May 11, 2016

RE: 2012 NC Building Code
Section 903.3.1.3, NFPA 13D Sprinkler Systems
Section 706, Fire Walls
Section 705, Exterior Walls
Section 202, Townhouse

I am writing you on behalf of our company Redwood Living out of Beachwood, Ohio. We are developing a property in Concord NC called Birchwood Commons. We have run into a discrepancy in the interpretation of the North Carolina Fire Code and I am writing you for clarification and your formal ruling.

2 HOUR SEPARATION WALL
 2 HOUR RATED ASSEMBLY AS PER . G.A. #3820 (SIM.)

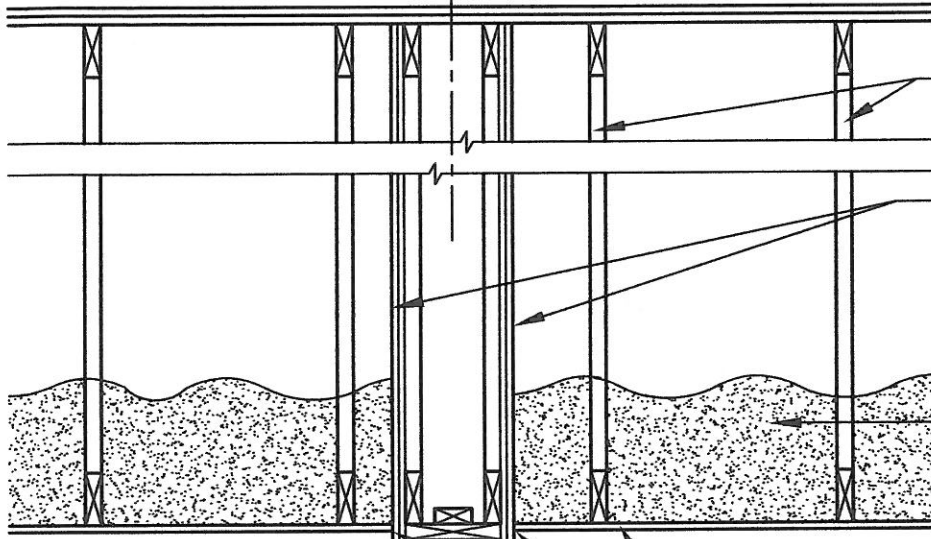
There is nothing vague about the original response to Question #1. If Fire Wall separations are provided between Townhouses, then an NFPA 13D sprinkler system is appropriate. The G.A. #3820 detail submitted with your 4/22/2016 request is identified as a 2-hour separation wall, but not as a Fire Wall. The Designer needs to identify it as such and indicate how it will allow collapse of construction on either side without collapse of the wall.
